**10COPLEY TOWNSHIP
ARCHITECTURAL REVIEW BOARD
JACOBY ROAD PARCELS 1501734,
1501735, 1503826
RESIDENTIAL CONSERVATION DEVELOPMENT
STAFF REPORT***

November 1, 2021

<p>*THIS IS A WORKING DOCUMENT</p> <p>PROJECT: Jacoby Road Rezoning Residential Conservation Development (R-CD) Parcels 1501734, 1501735, 1503826 (1625 Sunnyacres Road)</p>	<p>APPLICATION TYPE: Jacoby Road R-CD-General Development Plan</p> <p>Submitted: 10/12/2021</p> <p>Final Development Plan</p> <p>Review Requested: 7/5/2022</p> <p>Plan Updates: 10/26/2021: CED Comments; SSWCD Comments; 11/1/2021: ORAM, Tree Survey Summary Letter; 11/12/2021 ARB Site Visit; 3/25/2022 SCE Traffic Study Approved; Landscape Plan Submitted; Sewer Capacity Study Approved; 6/15/2022 Jacoby Road Neighborhood Meeting; 6/23/2022 Development Plan Checklist, Tree Preservation Plan Stem Inventory, Variance Review; 6/27/2022 Conservation Easement, ARB Motions for Consideration, SCPH Comment; 6/28/2022 Per the applicant variance review; 6/29/2022 Public Comment Letter from Spring Garden Waldorf School; 7/1/2022 Pride One request to ARB regarding authority Section 3.06 G. 10; 7/27/2022 Public Comment/Notification Document (SEE ADDENDUM A); Updated V

IMPACT DATA:

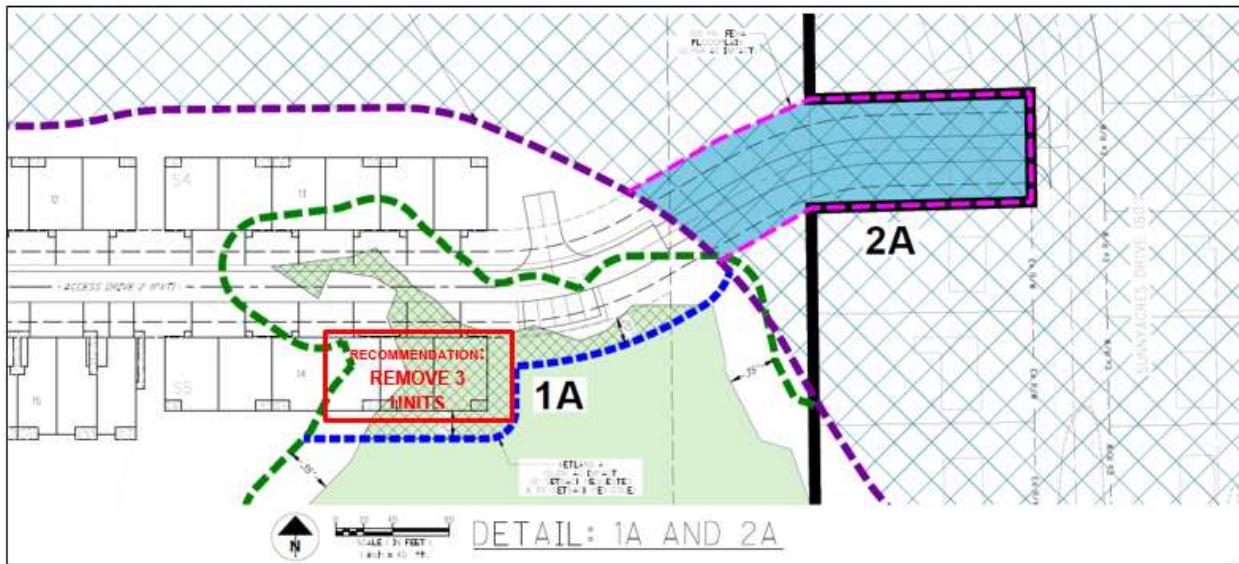
<u>1. WETLAND SETBACKS: (ARTICLE 3: 3.06 R-CD,G,6.b.,ii.)</u>				
MINIMUM CONSTRUCTION SETBACK OF 35' FROM EDGE OF WETLANDS				
No.	WETLAND	REQUIRED SETBACK	REQUESTED SETBACK	VARIANCE
1A	A	35'	0'	35'
1B	D	35'	12'	23'
1C	E	35'	0'	35'

<u>2. RIPARIAN SETBACK: (ARTICLE 15: 15.04,E.,1.)</u>	
RIPARIAN SETBACK SHALL EXTEND TO THE OUTER EDGE OF THE 100-YEAR FLOODPLAIN	
No.	100 YEAR FEMA FLOODPLAIN IMPACT
2A	0.454 AC

WETLAND A

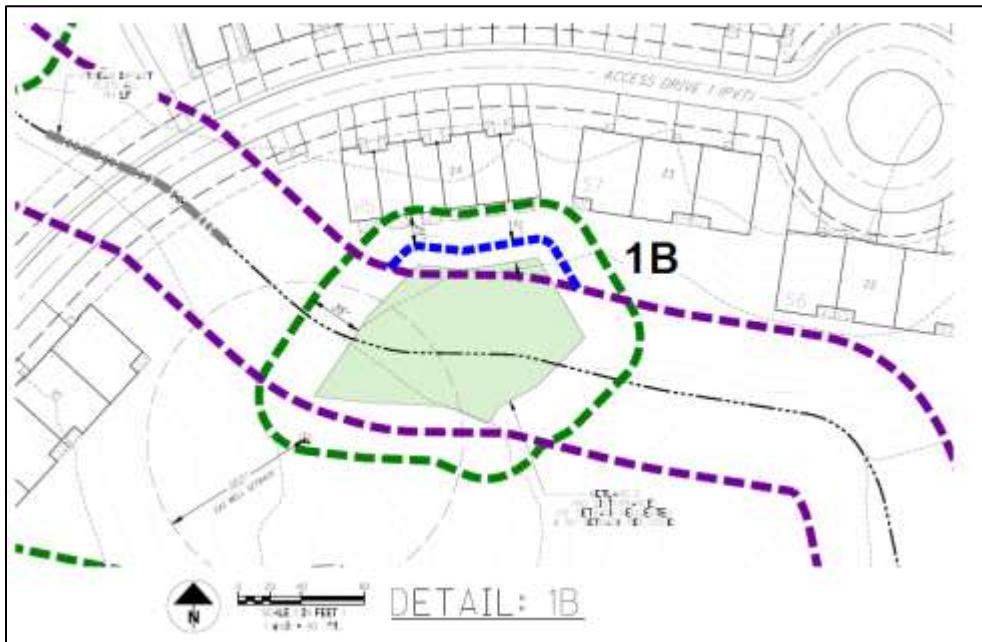
1 A (WETLAND A): The applicant is seeking approval to remove 0.261 acre of wetland for the construction of 3 units and installation of roadway and a 0' from the identified wetland.

STAFF RECOMMENDATION: Eliminate identified units to avoid wetland removal and maintain a wetland setback.

WETLAND D

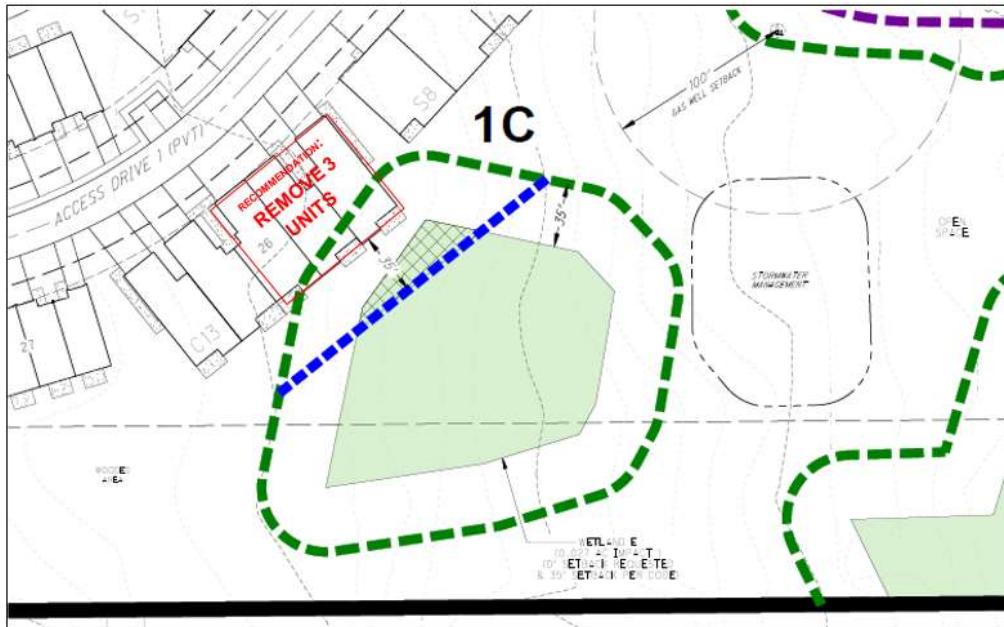
1B: Applicant is seeking relief from the required 35' wetland setback. There are no proposed impacts to the wetland area. The applicant is seeking approval to maintain a 12' setback from the wetland.

STAFF RECOMMENDATION: *Approval conditioned upon submission of a Preliminary Drainage Plan showing no upstream or downstream impacts as a result of the variance*

1 A (WETLAND A): The applicant is seeking approval to remove 0.261 acre of wetland for the construction of 3 units and installation of roadway and a 0' from the identified wetland.

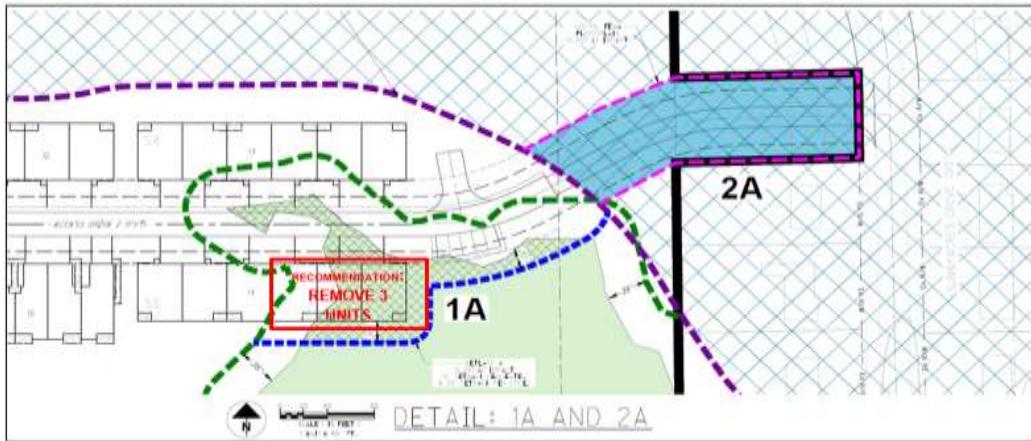
STAFF RECOMMENDATION:

Disapproval. Eliminate identified units to avoid wetland removal and maintain a wetland setback.

#8

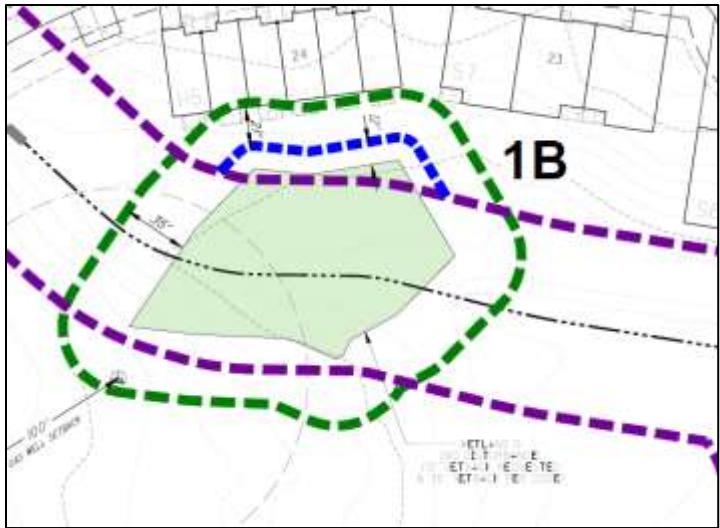
1B (WETLAND D): Applicant is seeking relief from the required 35' wetland setback. There are no proposed impacts to the wetland area. The applicant is seeking approval to maintain a 12' setback from the wetland.

STAFF RECOMMENDATION:

Approval conditioned upon submission of a Preliminary Drainage Plan showing no upstream or downstream impacts as a result of the variance

1C: (WETLAND E) Applicant is seeking relief from the required 35' wetland setback. The applicant is seeking approval to maintain a 0' setback from the wetland. Applicant is seeking approval to remove 0.027 acre of identified wetland.

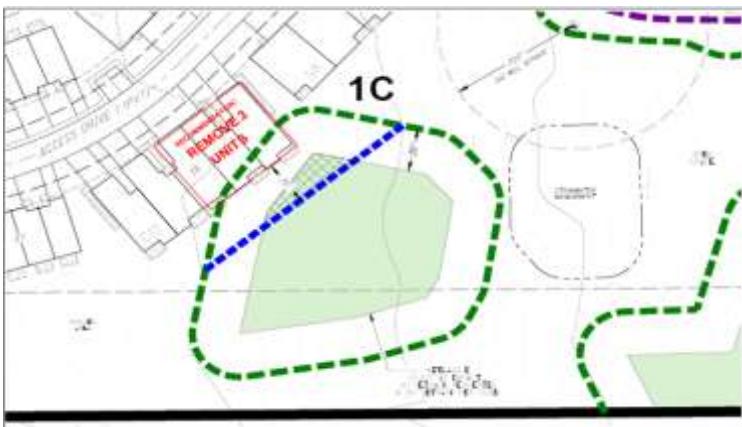
STAFF RECOMMENDATION:

OR Approval conditioned upon submission of a Preliminary Drainage Plan showing no upstream or downstream impacts as a result of the variance
